CITY OF ALBUQUERQUE

**RE: Coors Pavilion Subdivision
9154 Coors Blvd
Grading Plan
Engineer's Stamp Date 01-04-2017 (File: G11D069)**

Re: Coors Pavilion Subdivision –Grading Plan for Grading Permit

CITY OF ALBUQUERQUE PUBLIC WORKS DEPARTMENT ENGINEERING DEVELOPMENT GROUP		COORS PAVILION MASTER DRAINAGE PLAN SITE GRADING & DRAINAGE	
DESIGN REVIEW COMMITTEE	CITY ENGINEER APPROVAL	Mo./DAY/YR.	Mo./DAY/YR.
CITY PROJECT No.	ZONE MAP NO. K-09-Z	SHEET 1	OF 1

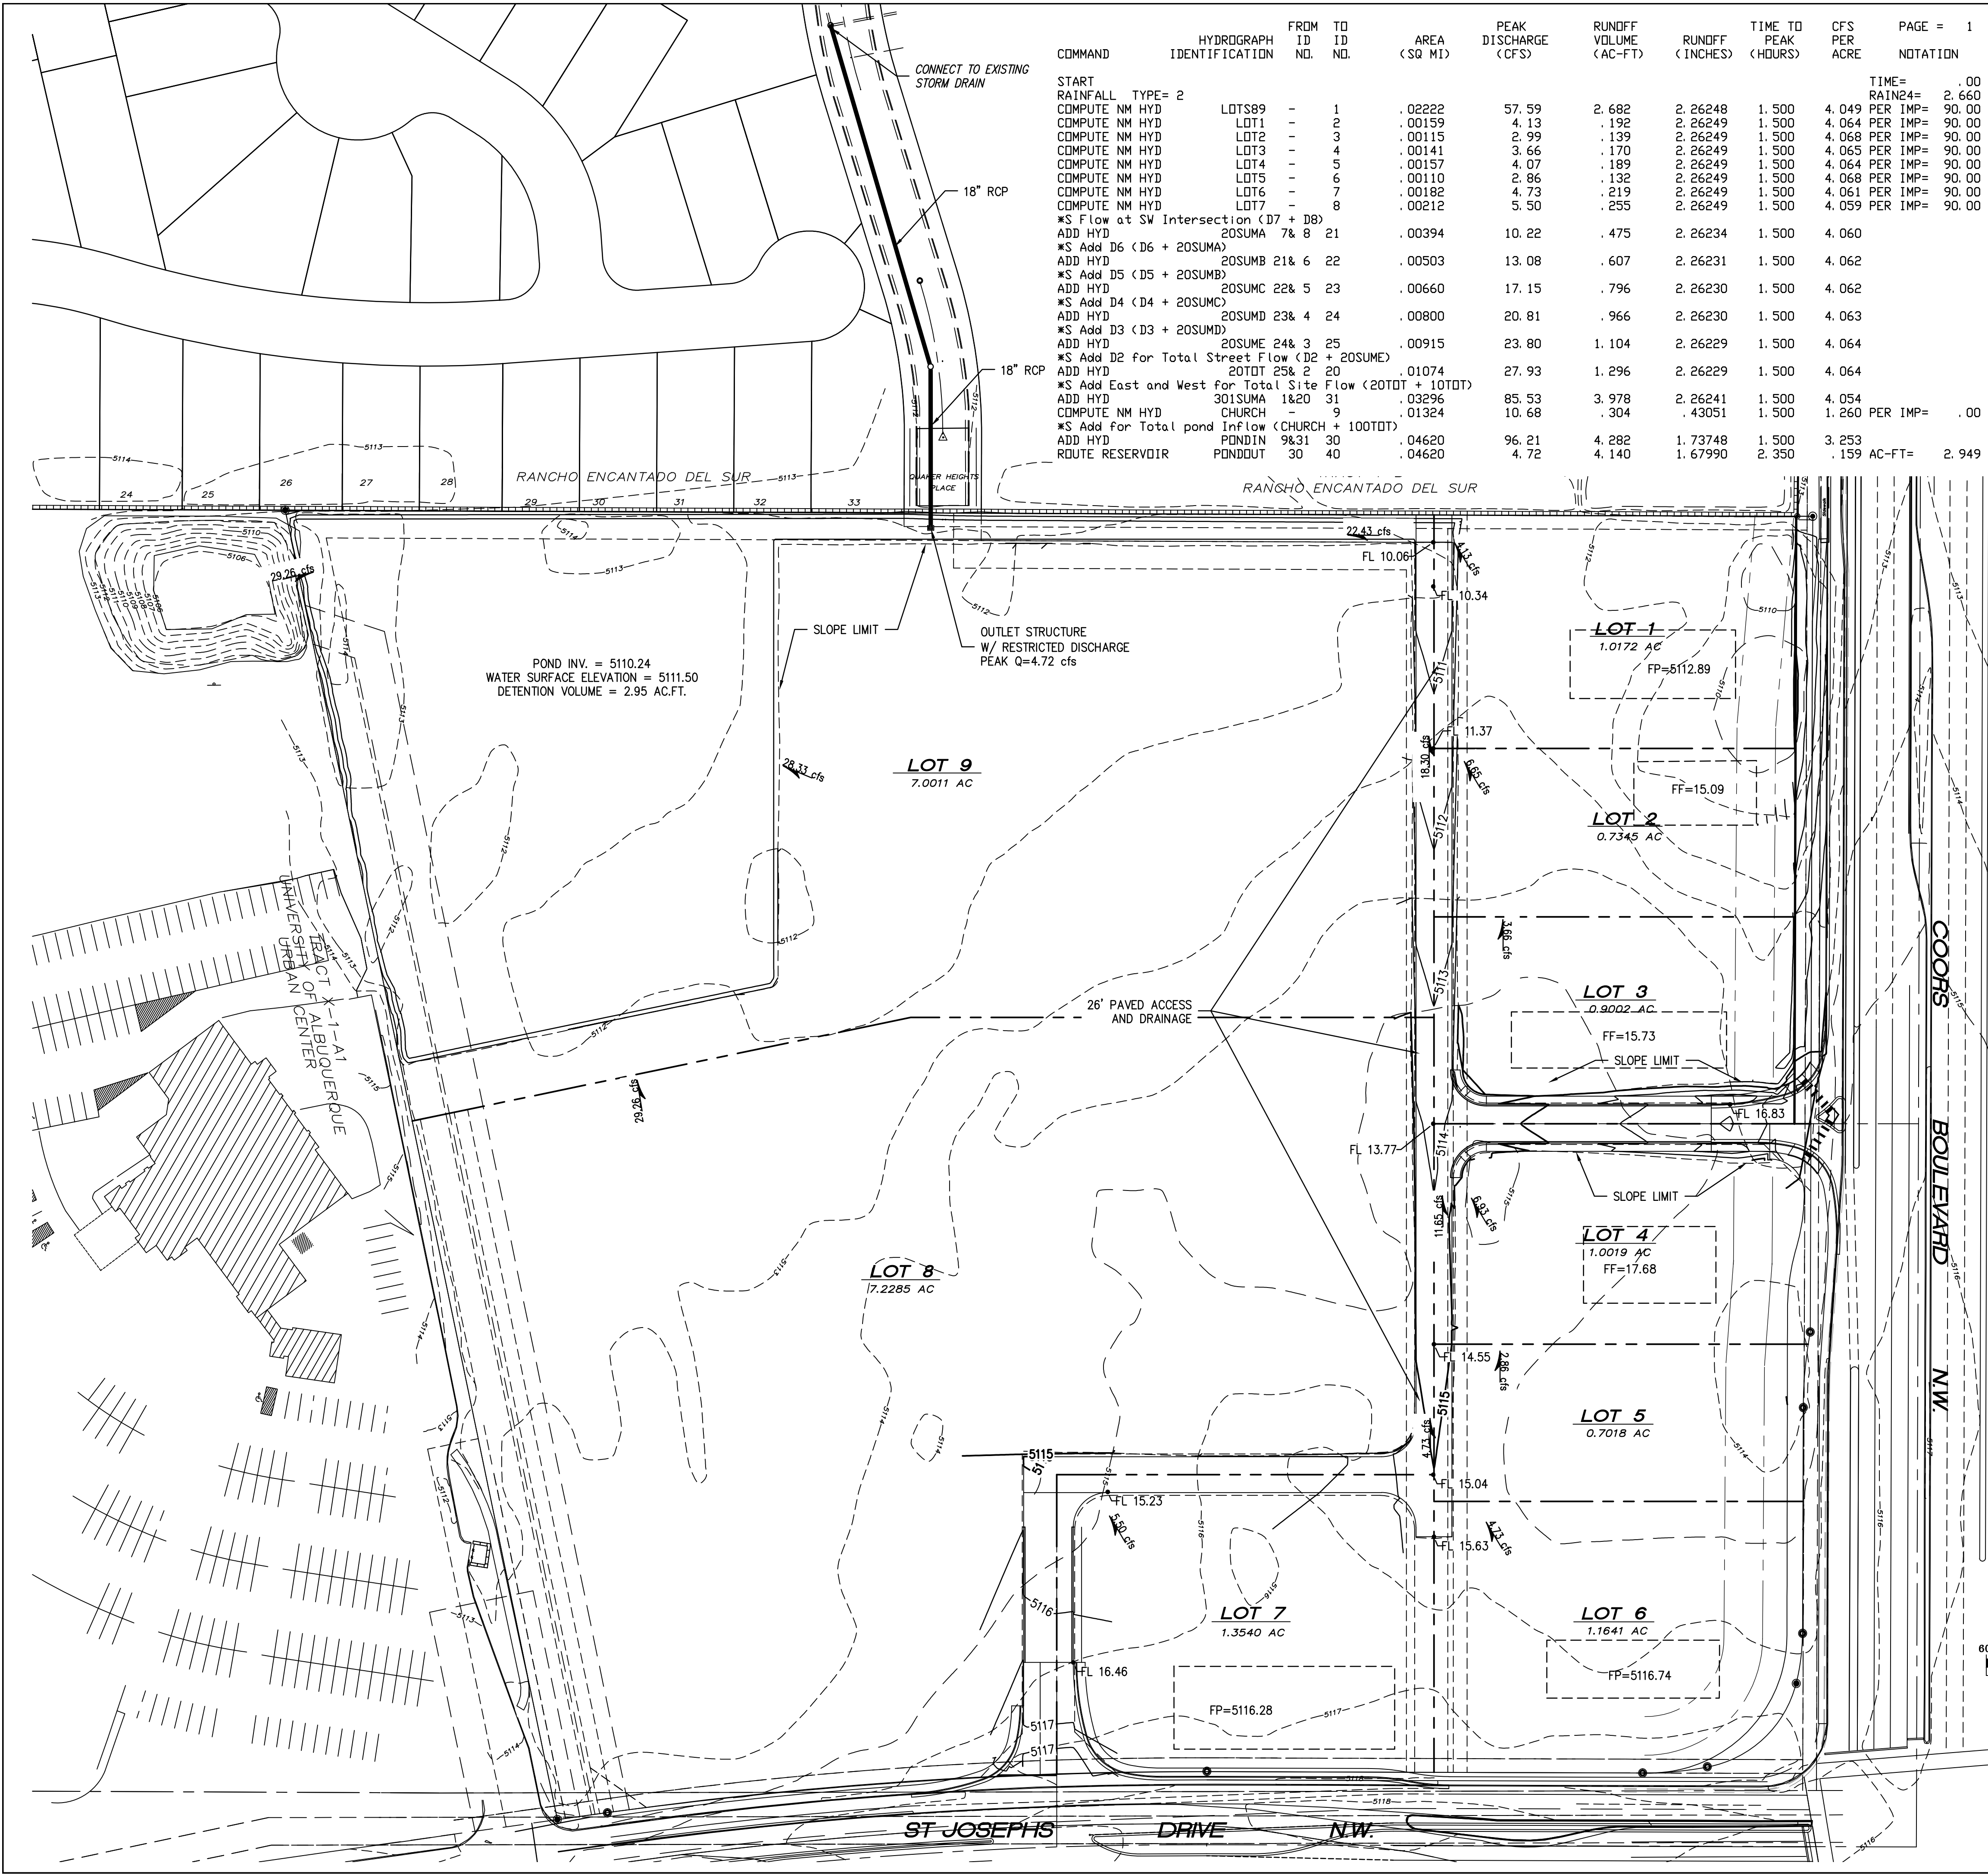
1. The AHYMO model routes discharge from Lot 7 into Lot 6, and along the alley to the north, then into the pond. However the drainage narrative and the drawing show Lot 7 as draining into Lot 8, then to the pond. The AHYMO model needs to reflect the drawing and narrative or visa-versa.

2. If discharge from Lot 7 is to be drained into Lot 8, a curb cut and dip section will need to be provided to take water out of the alley and into Lot 8.

3. Waterblocks will be required where the alley joins Coors and St. Josephs to prevent excess flows from entering and contributing to the drainage area. These may be present already but are difficult to see; provide spot elevations and callouts to clarify.

4. Clarify contributions from adjoining lot X-1-A1. The AHYMO model appears to refer to this as "Church" with a contribution of 10.68 cfs and 0% impervious area. The drawing shows a contribution of 29.26 cfs. Is the existing pond being merged with the new one?

5. Proposed contours need to be added to the legend and to the lots. On this sheet no regrading appears to be taking place across the new lots.
6. The proposed water surface elevation of 5011.50 will back up into the alley and across a large portion of Lot 1. Is this desired?

7. First flush volume needs to be calculated and shown on this sheet, as well as how it will be retained in the pond beneath the invert of the outlet structure.
8. Additional detail is required on the outlet structure and its downstream effects. This includes inverts, velocities, grades, and HGL's.
9. Provide the input and output files for the AHYMO model.
